Technical Guidance Committee Meeting

Minutes

Thursday, November 5, 2015

Figure 4-30. Effluent return locations and ratios from the recirculating gravel filter and flow splitter.

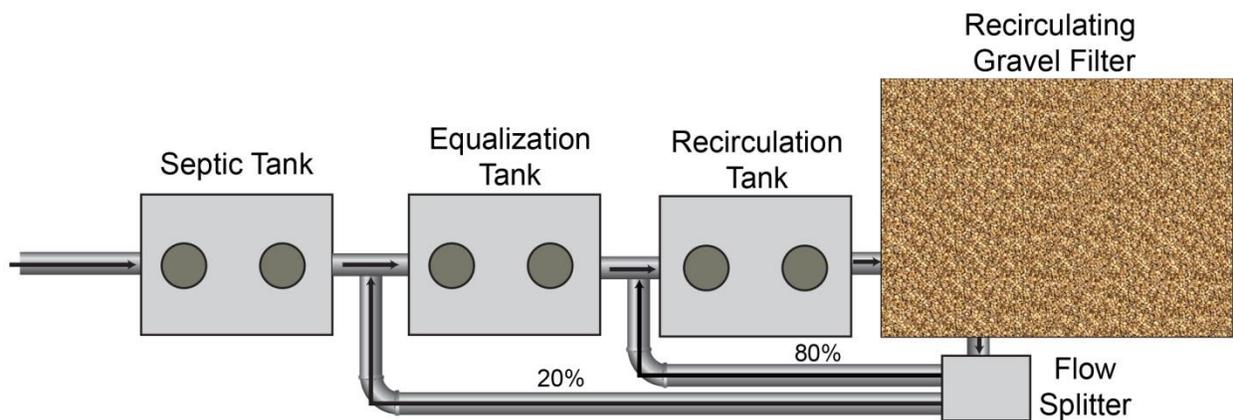
Tyler Fortunati presented a revision to the recirculating gravel filter system design that required effluent return from the filter to an equalization tank that also receives clarified effluent from a septic tank as requested by the committee at the July meeting. A new flow splitting device was also added to the design guidance.

Joe Canning had questions on the flow splitting and effluent return. Tyler Fortunati stated that the ratios included in the guidance were based on the requirements used by other states and EPA design guidance. Tyler Fortunati also stated that the flow splitting for effluent return was to be determined by the design engineer.

Figure 4-46. Cross-sectional view of a subsurface flow constructed wetland.

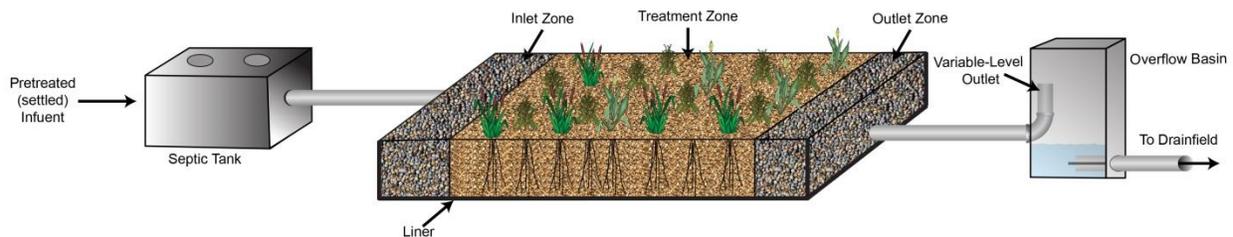
Action Item: Move the arrow in Figure 4-46 identifying the liner location.
